**From:** Ankit Panday <ankit@genarch.in>  
**Sent:** 21 May 2024 13:32  
**To:** Santosh Tambe  
**Cc:** Sitaram Mistry; Prakash Mistry; 'GAPL'; Khushbu Verma; 'Abdul Rehman'; Sandeep Bhat K-Corp; 'Swapnil Sutar'  
**Subject:** RE: FW: KFC food court T1 equipment list

**Subject:** FW: FW: KFC food court T1 equipment list

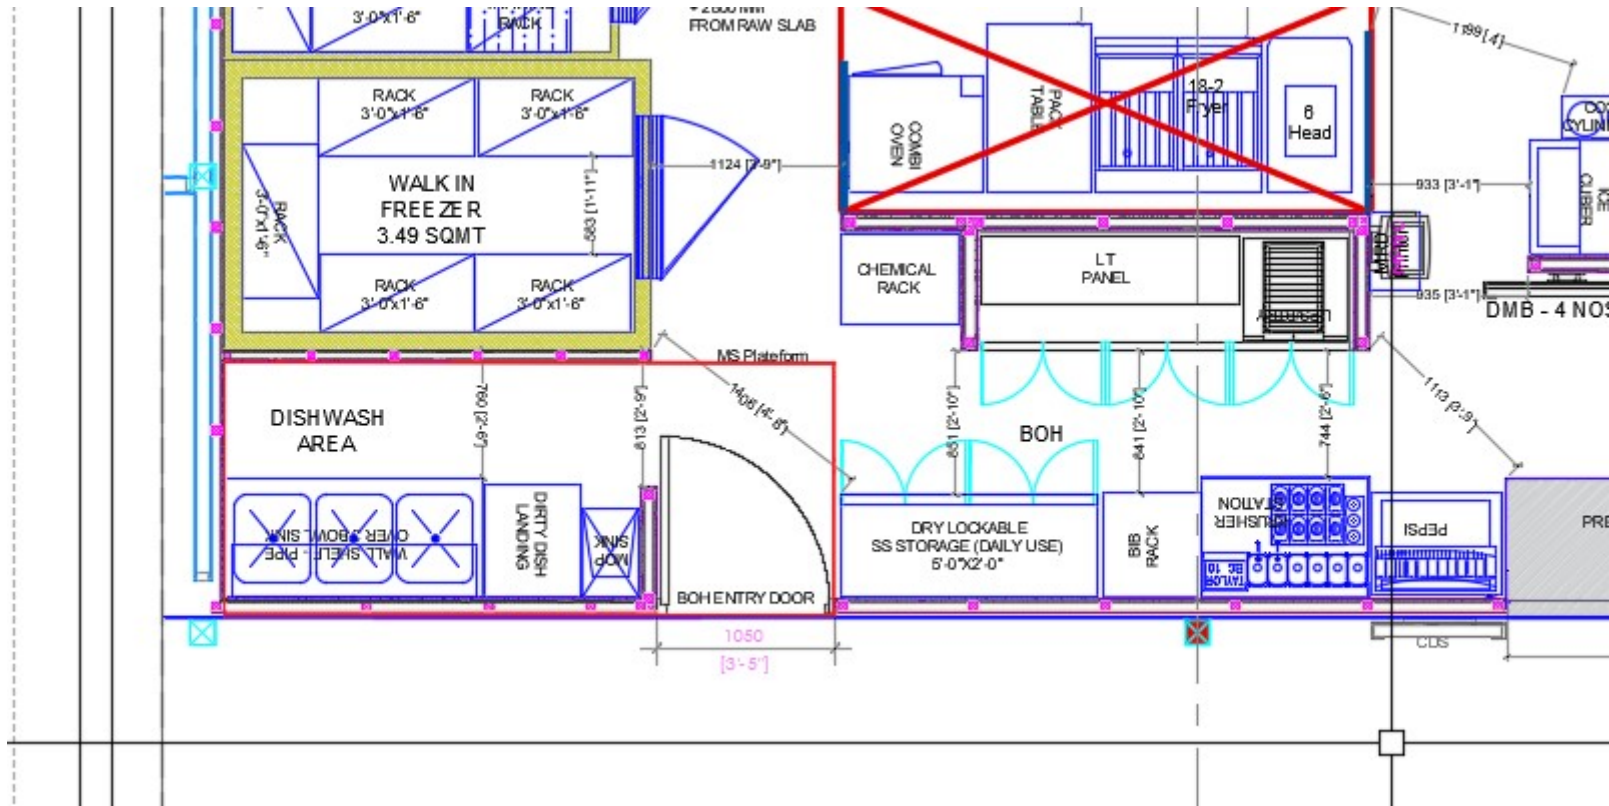
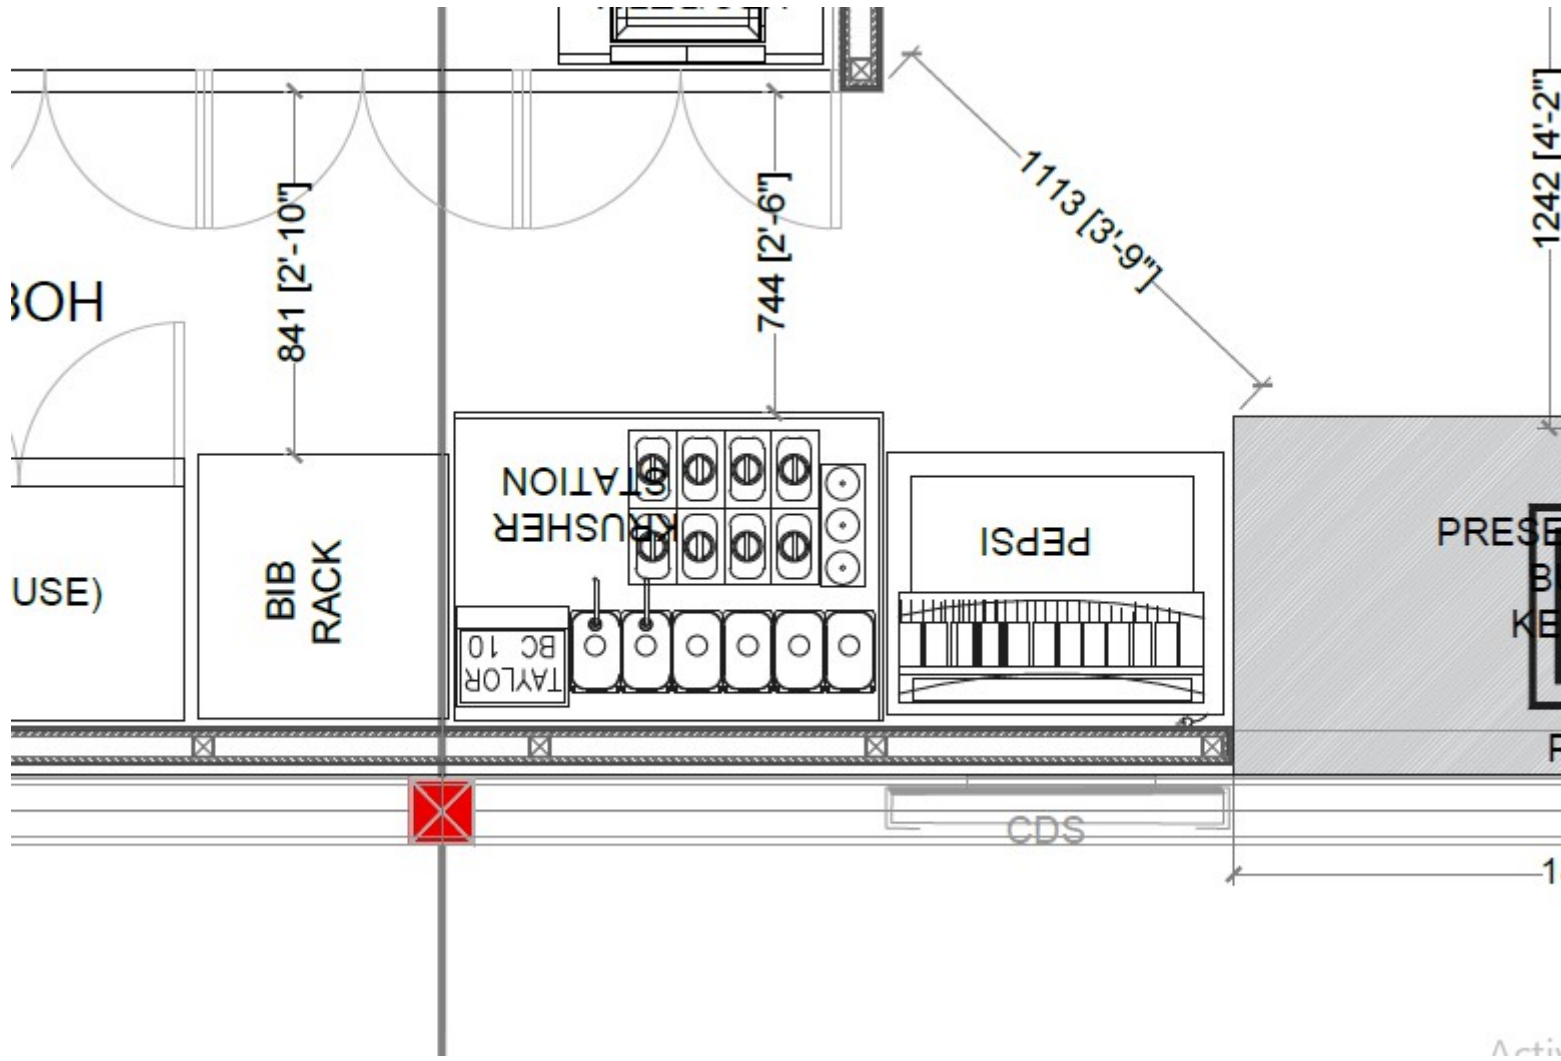
I have not found the Grease trap equipment in the Drainage as well as in the General arrangement plan.

The Krusher station in the equipment list is located near the Pepsi Machine.

However, I am concerned about the grease trap/ Crusher that is required below the Three Sink in the Washing area.

Request you to please clarify on the issue on priority.
